5440 WADE PARK BLVD, SUITE 102 WWW.BGEINC.COM NC LICENSE #C-4397 ©2023	DESIGNED BY:				
	DRAWN BY:				
	REVIEWED BY:		DF		
			DF/JWM	10/02/2023	PER TOWN OF ROLESVILLE COMMENT
				08/01/2023	PER TOWN OF ROLESVILLE COMMENT
		REV	06/01/2023	INITIAL SUBMITTAL

PARKER RIDGE
82 SCHOOL STREET
ROLESVILLE / NORTH CAROLINA / 27571

CARVED STREET CT PLAN
AND PROFILE

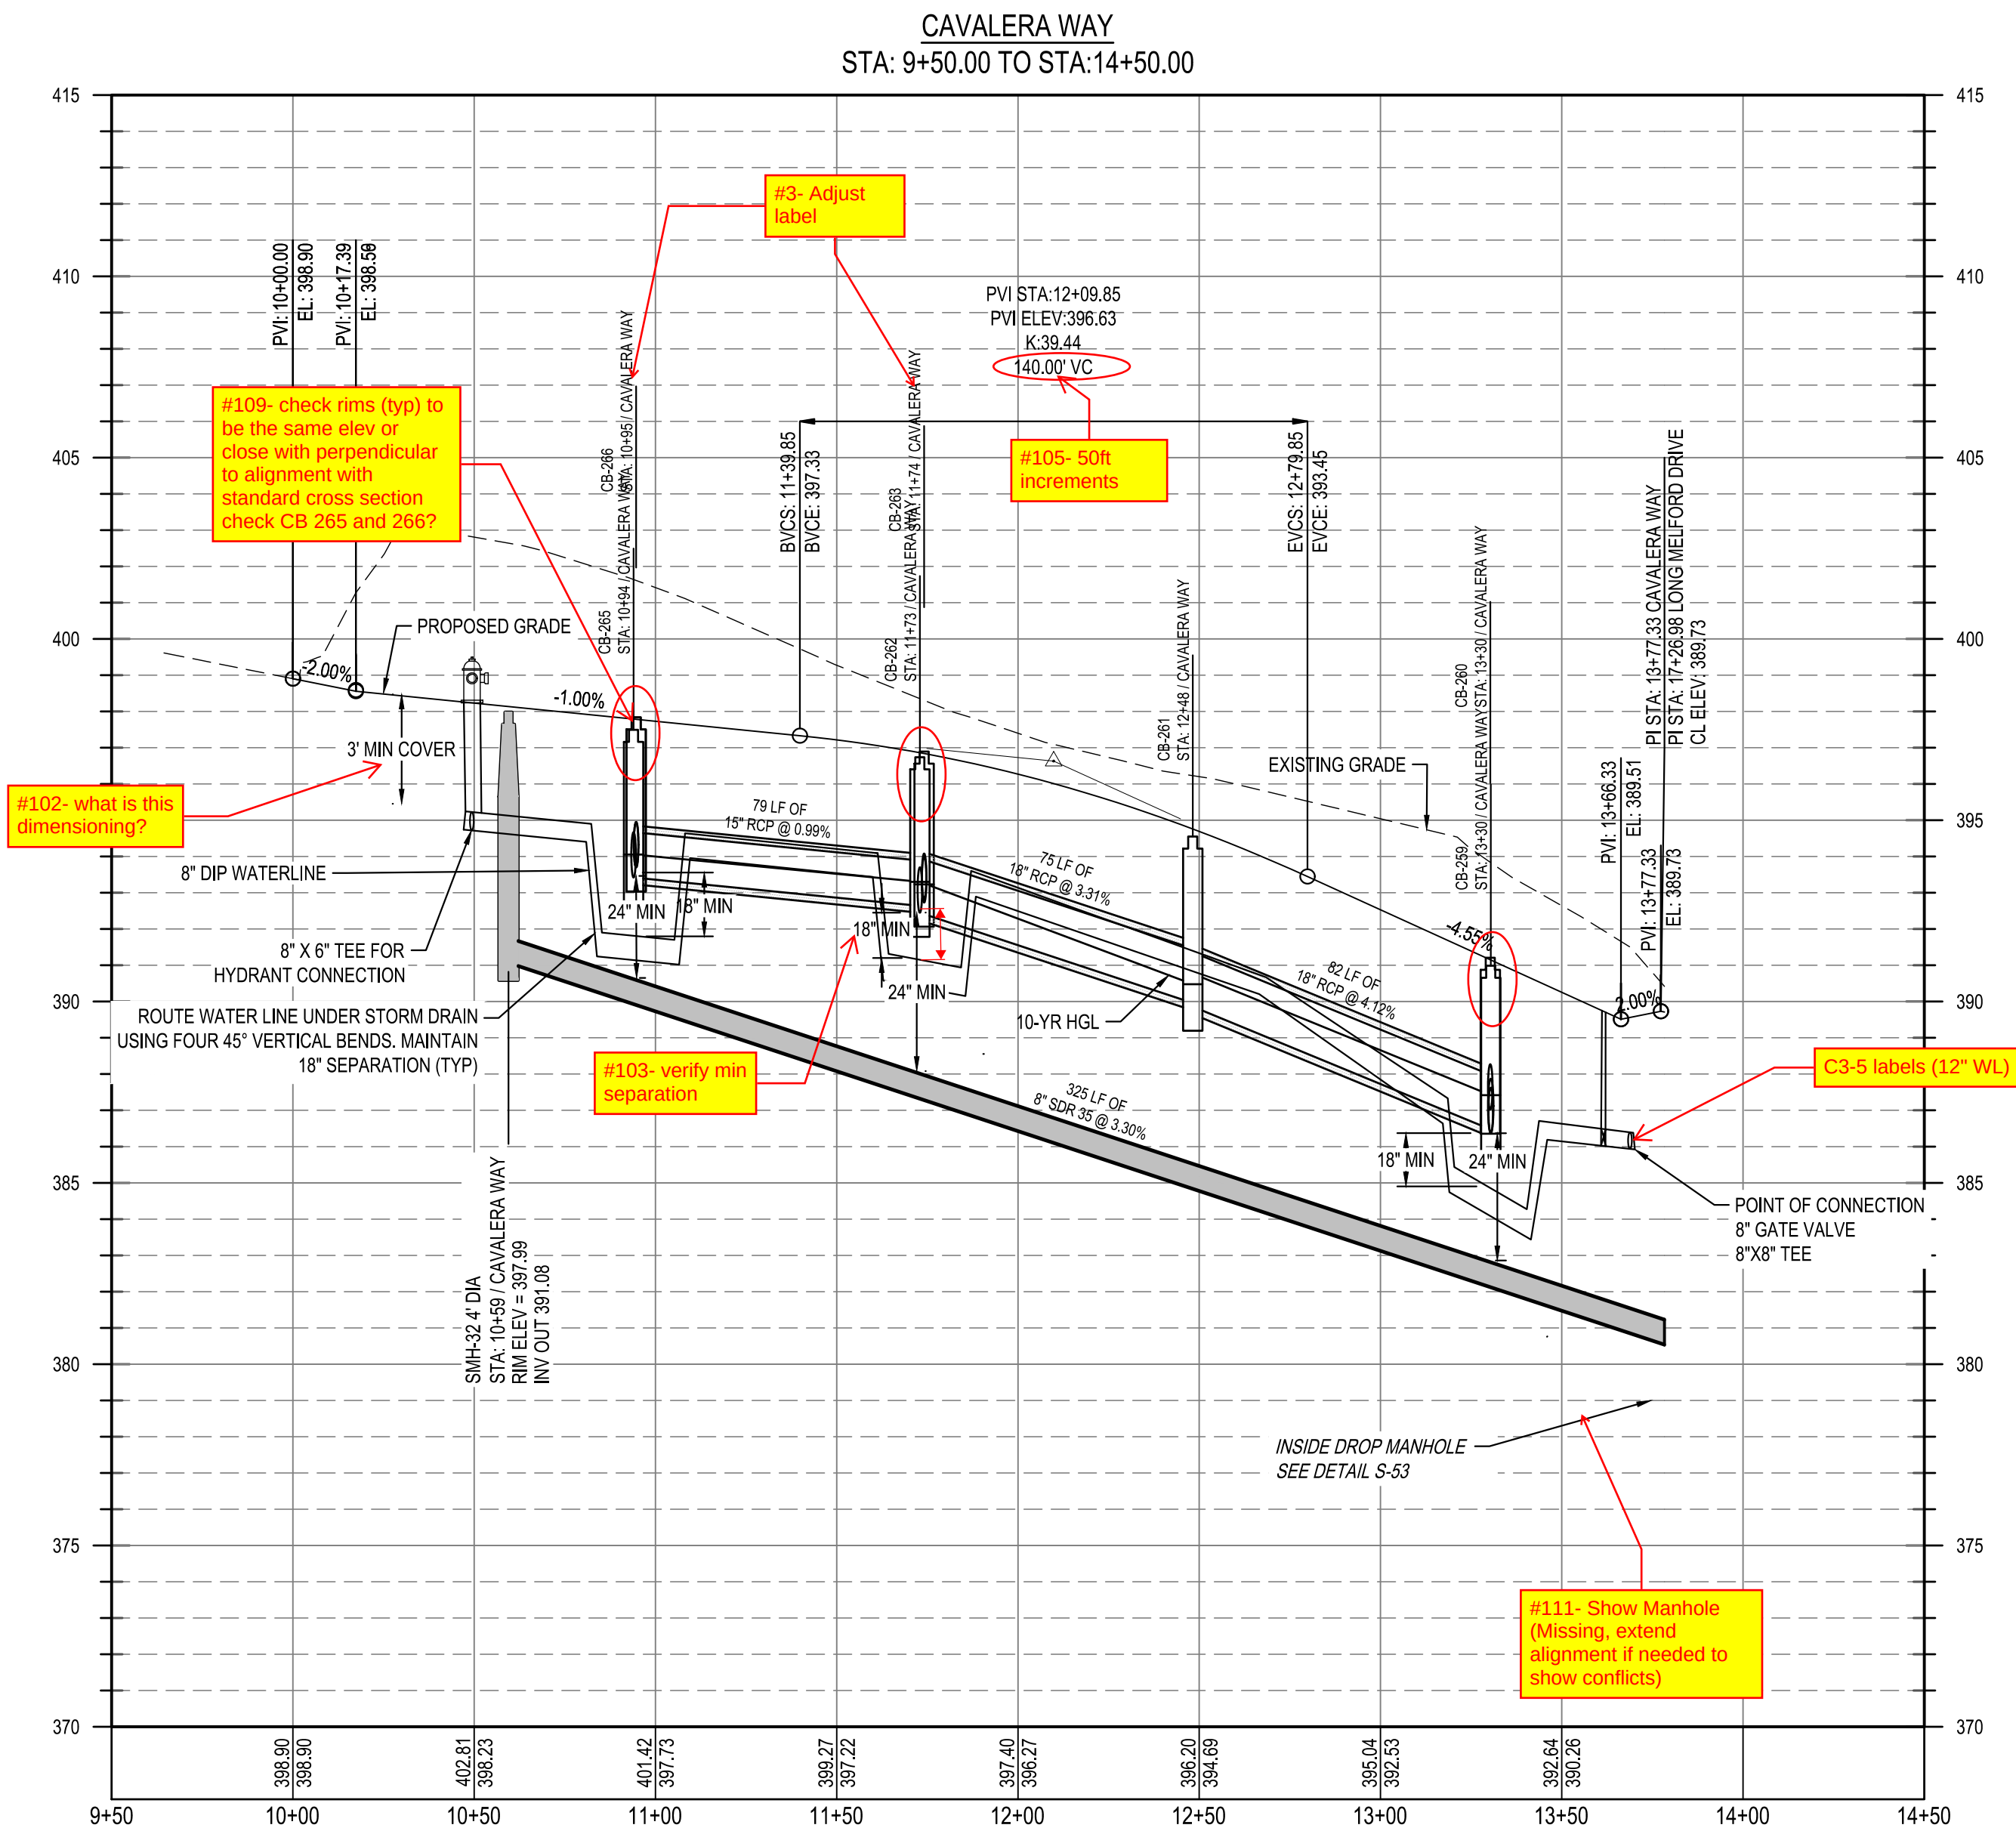
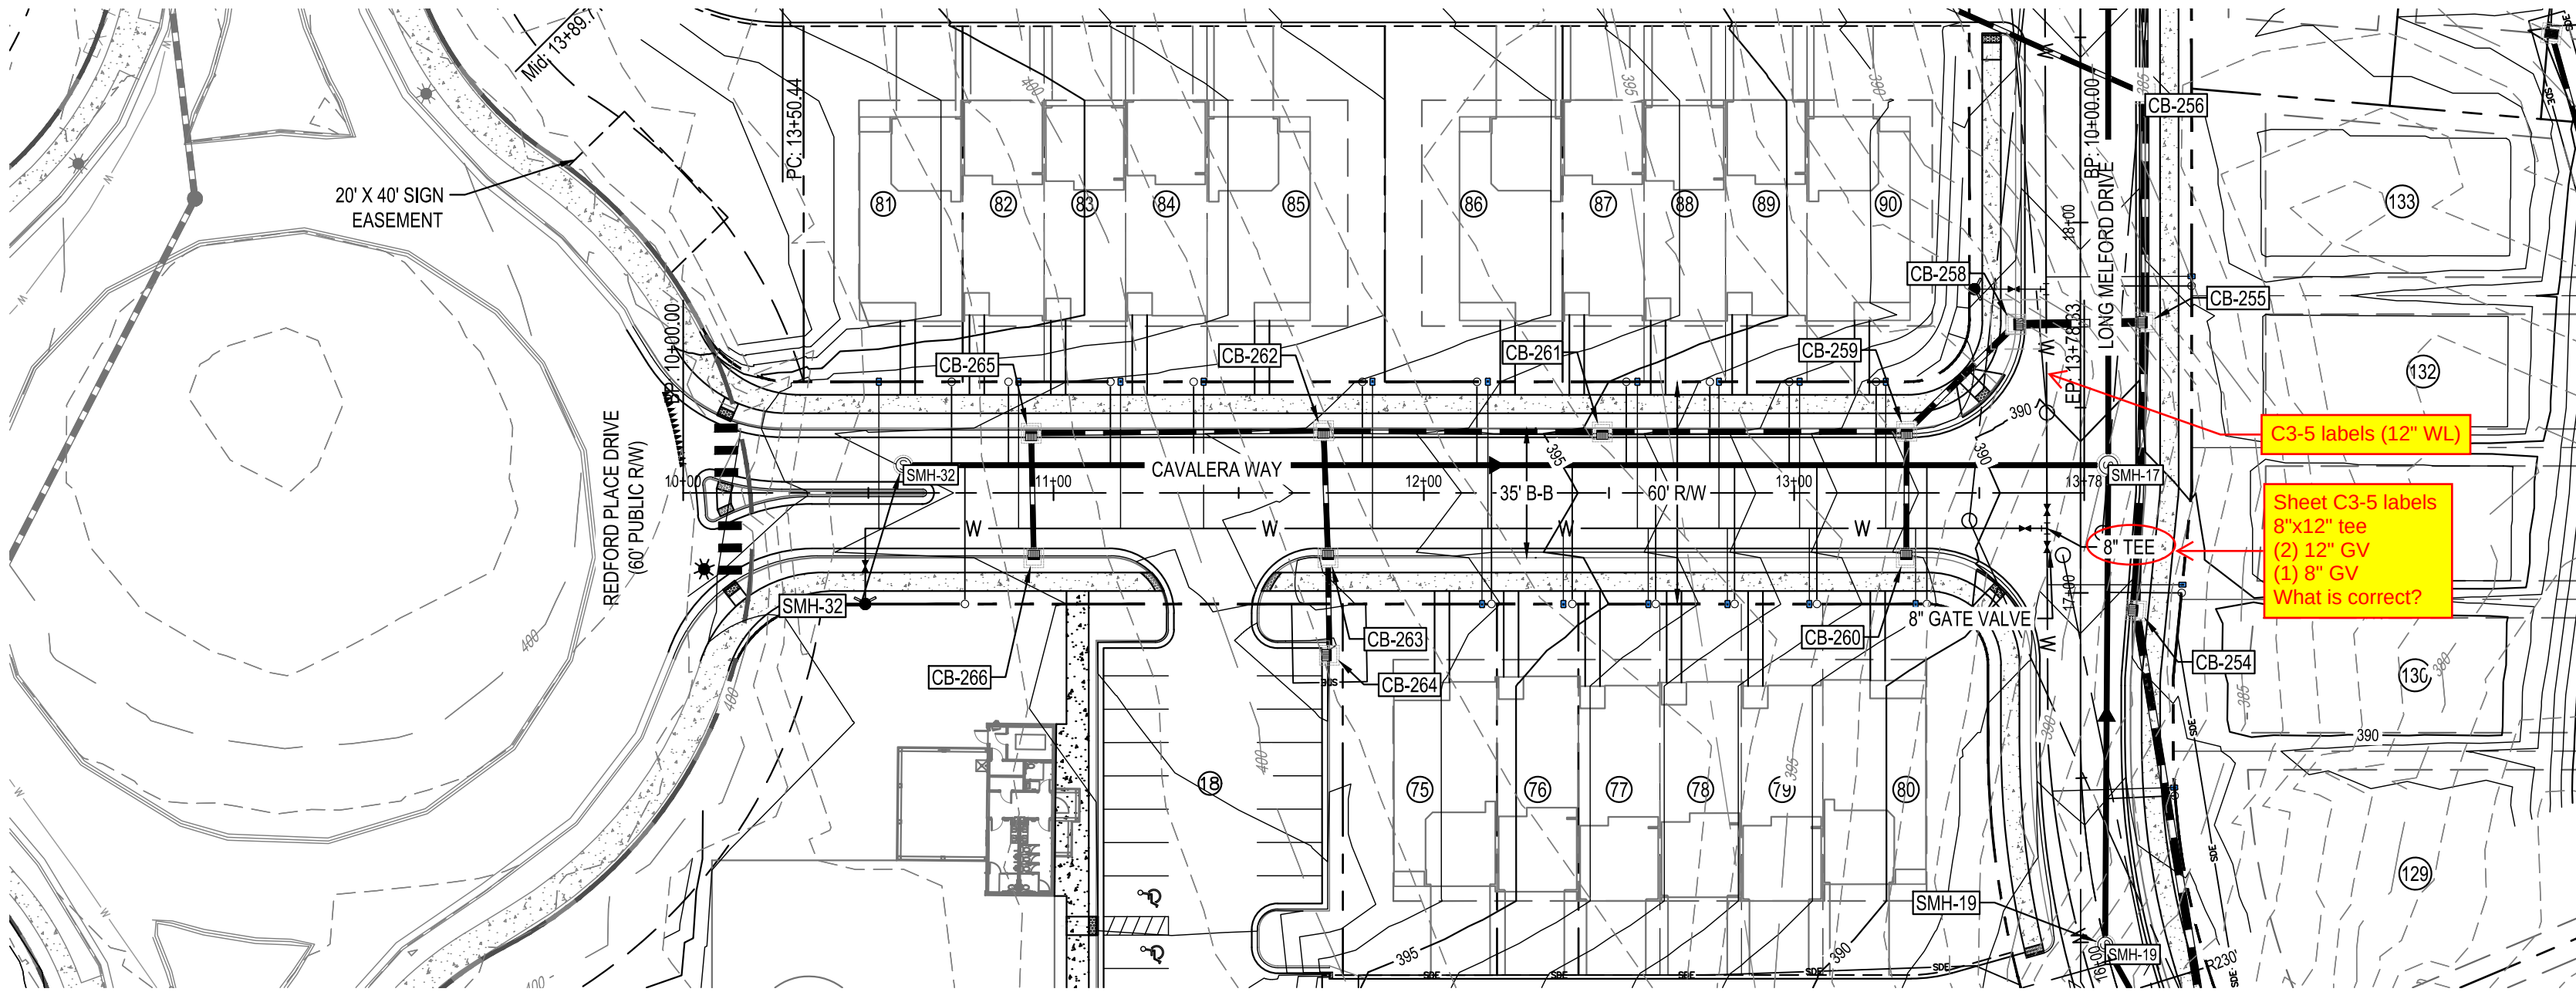
#102- Make sure dimensions are in the correct locations and it is clear what is being dimensions. Some dimensions don't seem to line up with top/bottom of pipes. If crossings do not meet minimum requirements, the design will need to be adjusted. Minimum separation requirements should be shown at all pipe crossings. This comment applies to all profile sheets.

#23- There are several instances where water line, tees/crosses, and valve sizes differ between Utility plan sheets and Plan and Profile sheets. Please make the necessary adjustments to ensure that water lines, connections, and valves correct sizes remain consistent throughout all sheets.
